STATE OF NEW YORK
DEPARTMENT OF ENVIRONMENTAL CONSERVATION

Entergy Nuclear Indian Point 2, LLC and
Entergy Nuclear Indian Point 3, LLC

PREFILED TESTIMONY OF JOHN R. YOUNG, PH.D.
IN SUPPORT OF ENTERGY NUCLEAR INDIAN POINT 2, LLC, ENTERGY
NUCLEAR INDIAN POINT 3, LLC AND ENTERGY NUCLEAR OPERATIONS, INC.

CLOSED CYCLE COOLING

Figure ES-2
Tetra Tech Configuration
(NYSDEC Staff Proposal)
Indian Point Energy Center
Village of Buchanan, Town of Cortlandt
Westchester County, NY

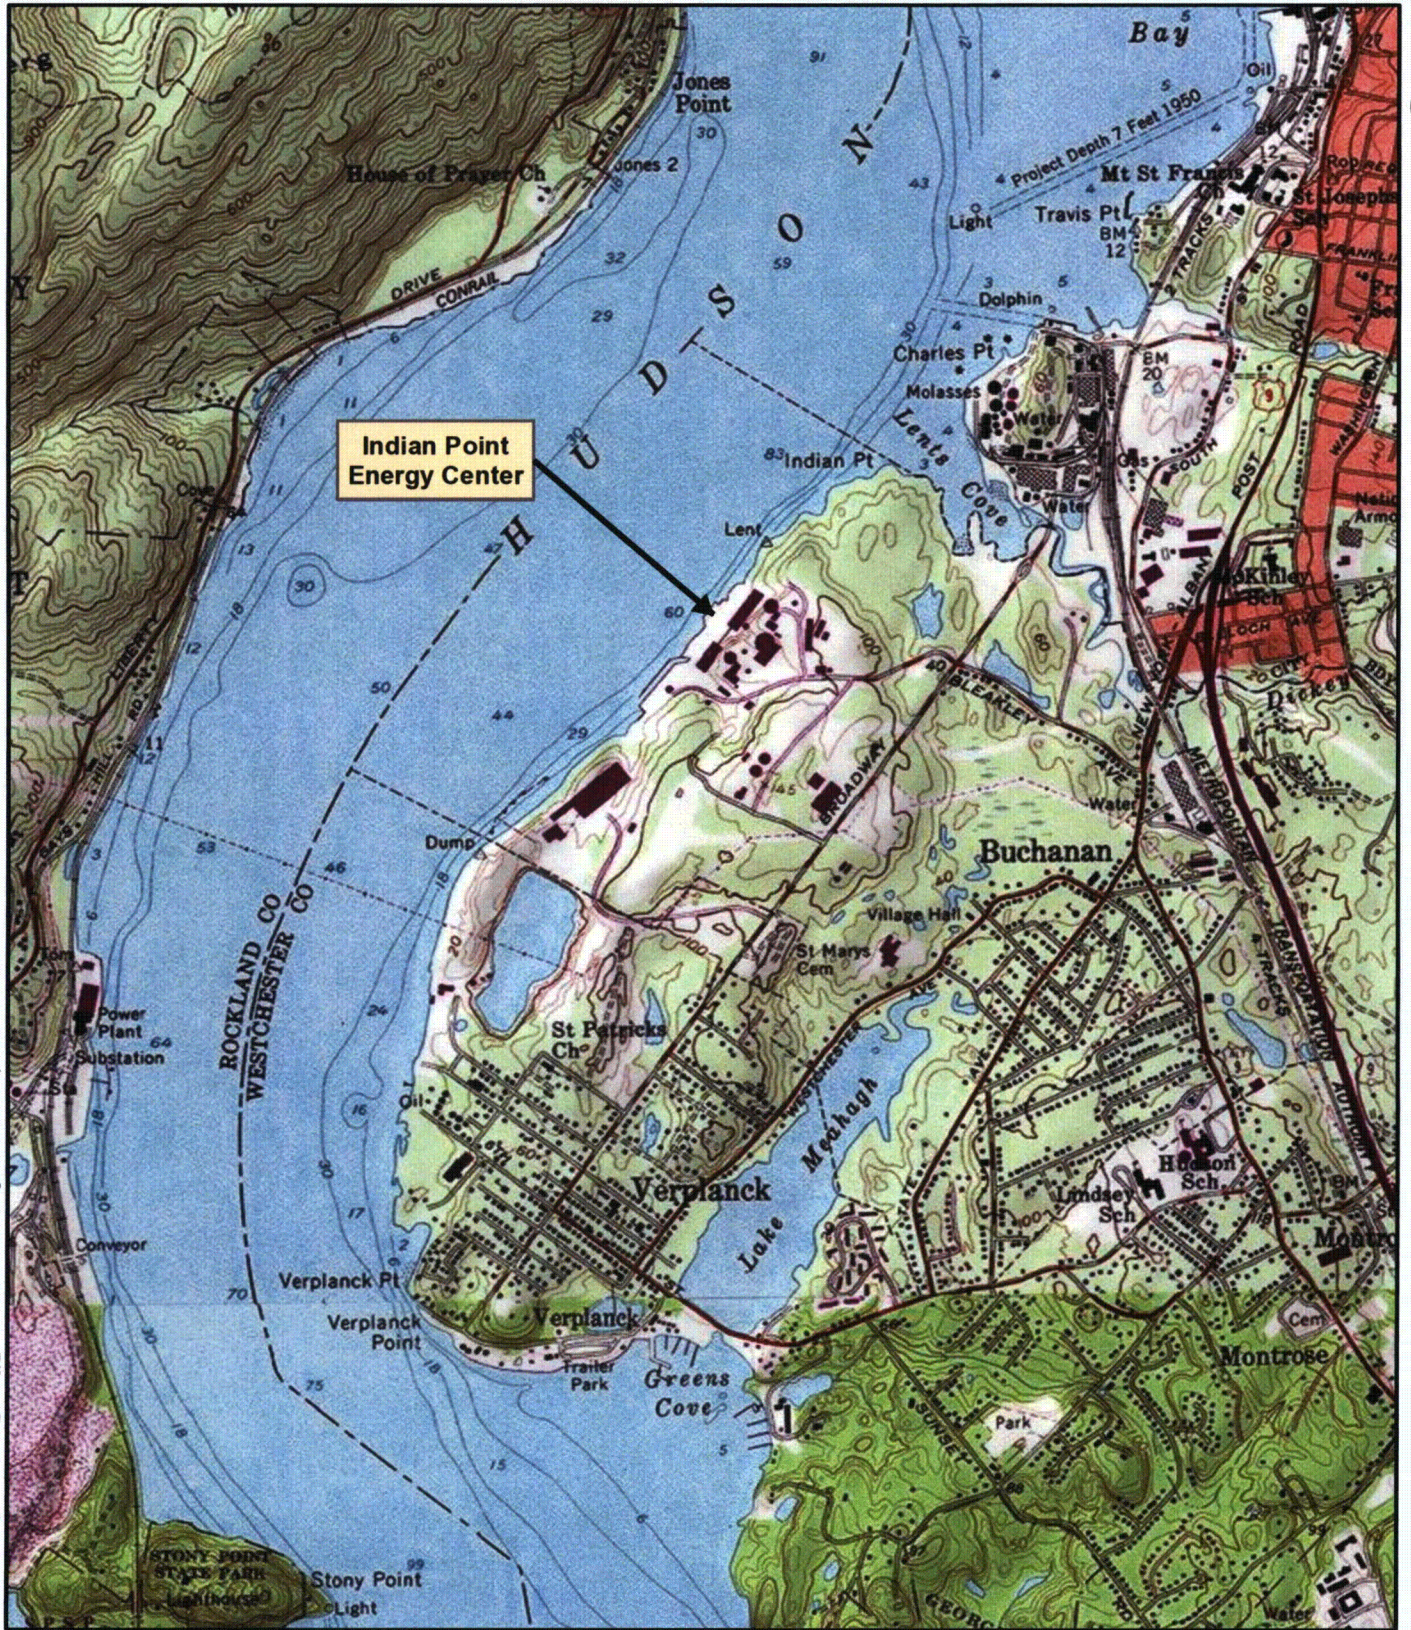
- **Cooling Tower Siting Conflicts:** Based on Entergy personnel walkdown observations and review of Figure 3-3 in the Tetra Tech Report, the proposed cooling towers impact several existing structures, including essential structures and components, the independent spent fuel storage installation, structures and components containing radionuclide material, and IPEC site security. Tetra Tech offers no plan to resolve these conflicts and several essential components are inexplicably displaced with no mention of the impact to the plant's ability to function. The proposed design compromises the plant's ability to generate power as well as its safe and secure operation. Tetra Tech did not address whether these structures are capable of being moved. If capable of being moved, Tetra Tech did not account for the cost and schedule impacts of doing so. The number and significance of the siting conflicts unresolved by Tetra Tech would result in a detrimental effect to IPEC, and as such the NYSDEC Staff Proposal cannot be considered an available technology as defined in the Indian Point Interim Decision (NYSDEC 2008).

1. **Cooling Tower Siting Conflicts:** Using Figure 3-3 in the Tetra Tech Report, the location of the cooling towers would require re-location and/or demolition of a significant number of existing Station structures and equipment, including essential plant components and components containing radionuclides (in the form of spent nuclear fuel and low-level radionuclide material). Tetra Tech did not in some circumstances, even identify and in all circumstances failed to address the adverse impacts to plant structures and equipment, including whether these structures are capable of being moved and relocated on-site. Even if capable of being relocated on-site, Tetra Tech did not account for the cost and schedule impacts of doing so. The number and significance of the siting conflicts unresolved by Tetra Tech would result in a detrimental effect to IPEC, and as such the NYSDEC Staff Proposal cannot be considered an available technology as defined in the Indian Point Interim Decision (NYSDEC 2008). It also represents major unaddressed engineering challenges that undermine a feasibility conclusion.

Figure 2-2
Transmission Line Overlay on Tetra Tech Configuration (NYSDEC Staff Proposal)
Indian Point Energy Center
Village of Buchanan, Town of Cortlandt
Westchester County, NY

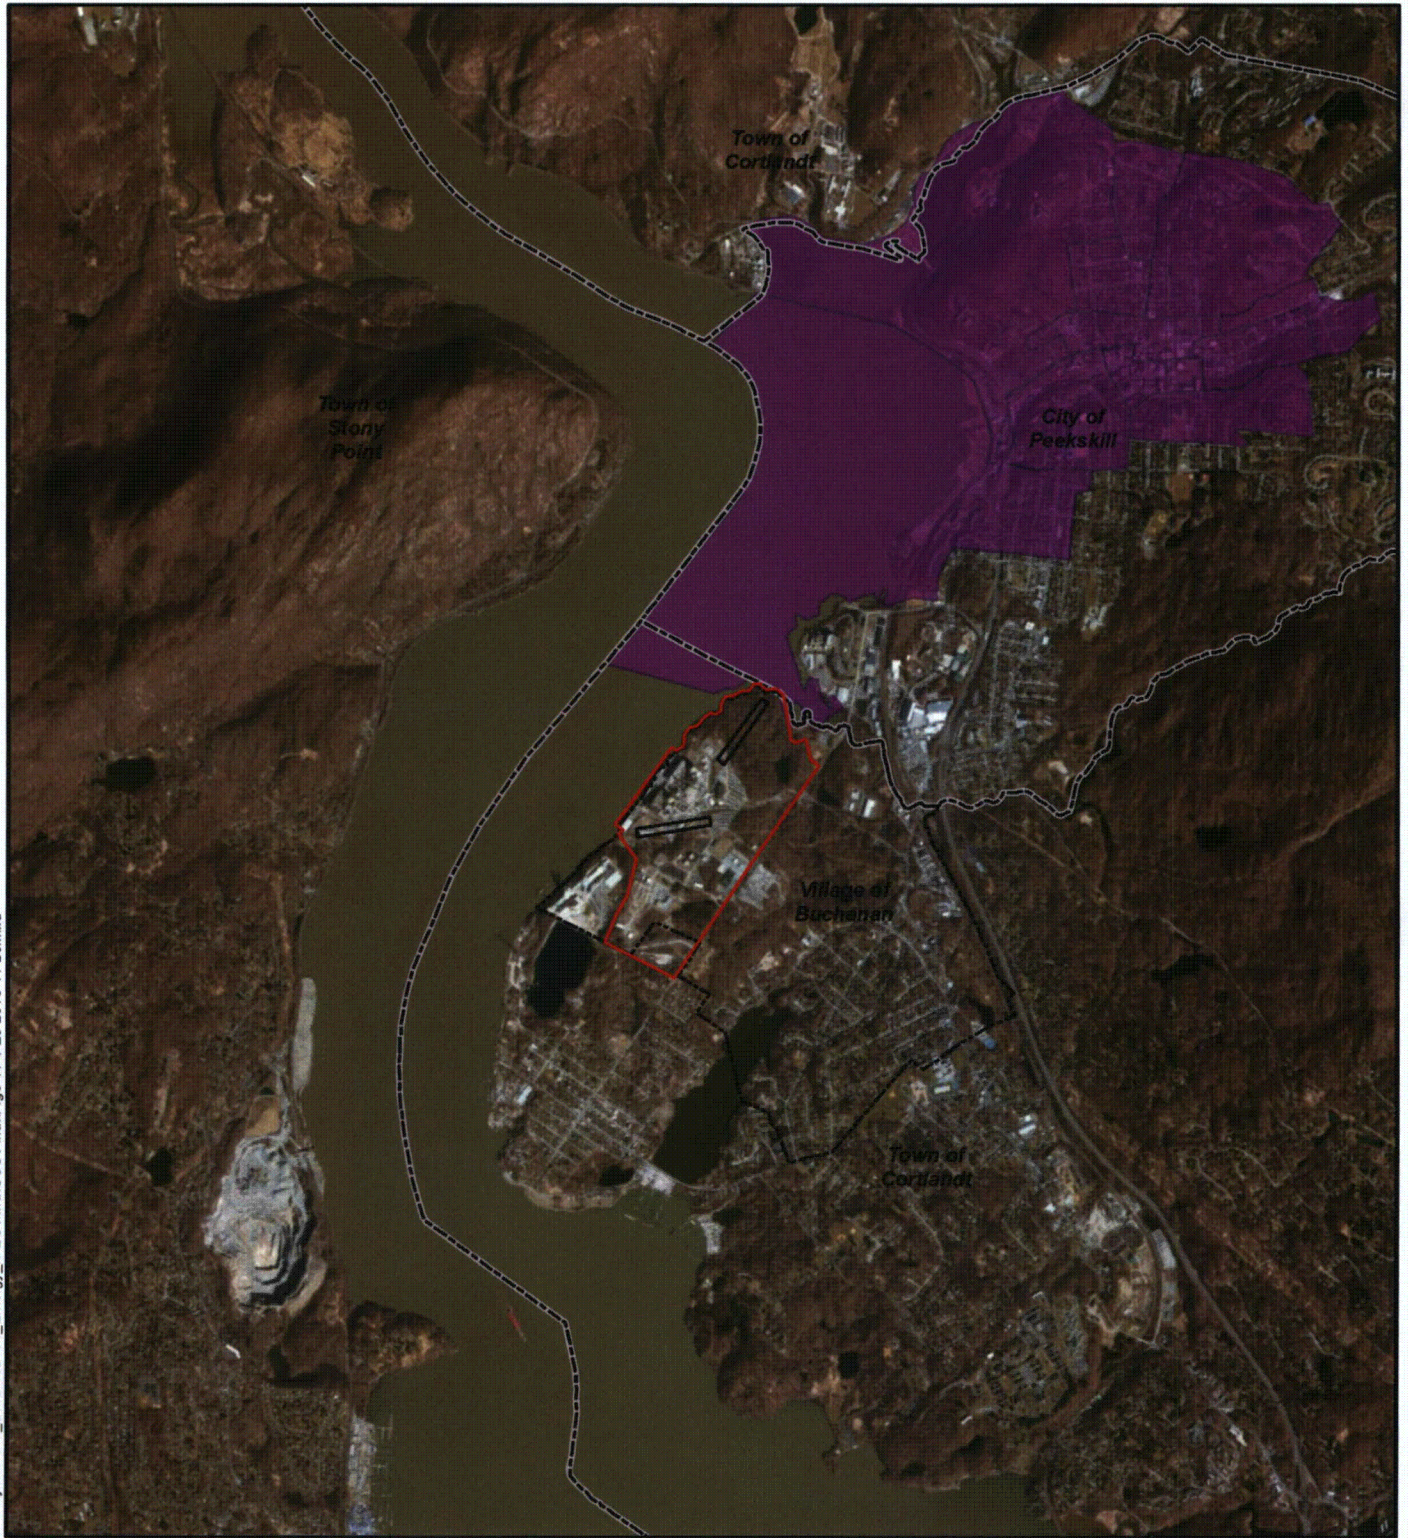
- **Power Transmission Line Impacts:** Tetra Tech's proposed cooling tower location directly interferes with the existing overhead 345 kilovolt ("kV") main transmission lines (and one (1) of the towers) to the power grid and the 138 kV auxiliary power lines from the Buchanan Substation to IPEC. The relocation of these lines (with appropriate clearances) and any underground control cables and the cost are not addressed in the Tetra Tech Report (Figure 2-2).
